SUBJECT: Forwards responses to NRC 800717 questions concerning radwaste from condensate polishing demineralizing sys.

August 29, 1980  
L-80-283

Re: Turkey Point Units 3 & 4  
Docket No. 50-250, 50-251  
Radwaste from Condensate  
Polishing Demineralizing System

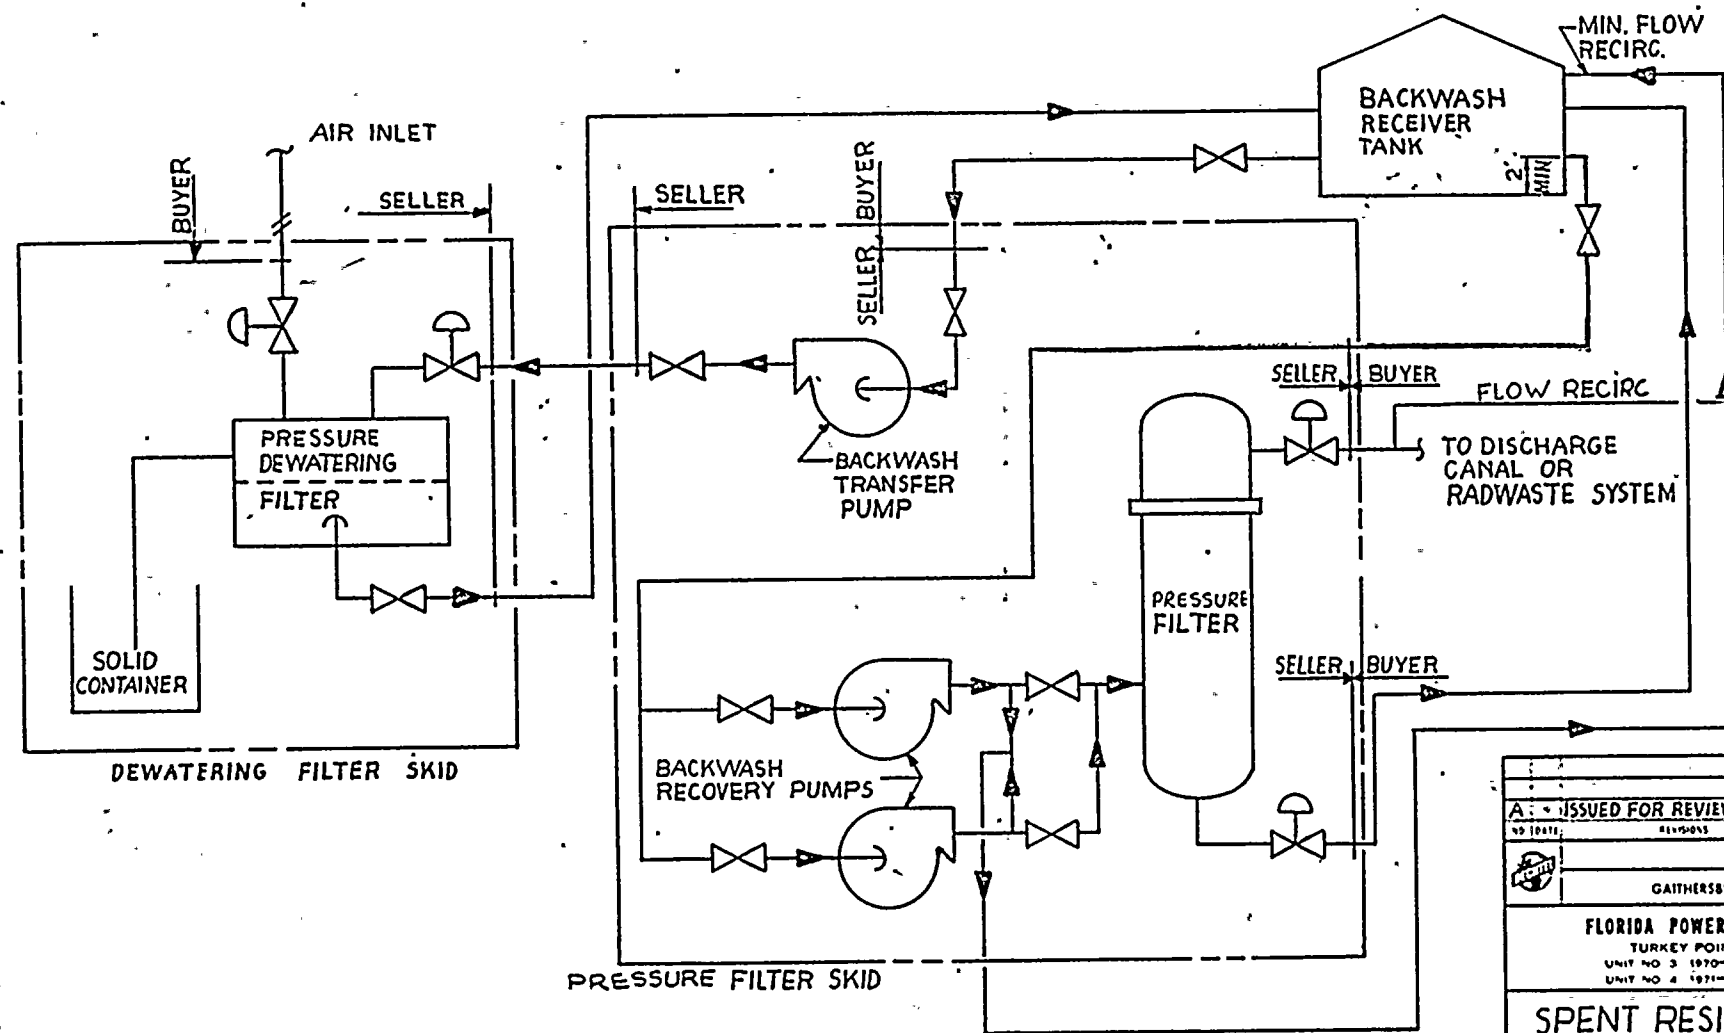
- 2) The following provides a description of the operation of the spent resin handling system. A preliminary drawing of the spent resin handling system is attached for reference.

Spent filter media is flushed from a condensate polisher vessel into the backwash receiver tank. The first phase of water/solids separation occurs in the backwash receiver tank where the heavier solids settle to the bottom of the tank.

The second phase of water/solids separation occurs in the pressure filter. At a preset level in the backwash receiver tank, a backwash recovery pump starts to recirculate the liquid contents within the tank. The water recirculating through the pressure filter is further cleaned of solids. If necessary, a representative sample of the tanks liquid contents can be collected at this time. The liquid contents of the tank can either be directed to the plant's radioactive liquid waste effluent system or directly to the facility cooling system as warranted.

The third phase of water/solids separation takes place in the de-watering filter. Solids from the backwash receiver tank (which is sized to hold the solids from ten backwashes) are processed via the backwash transfer pump and dewatering filter. This process completes the separation of the high density solids from the liquid which is returned to the backwash receiver tank. The de-watered solids are then transferred to a suitable container. Here samples can be collected and analyzed for radioactivity.
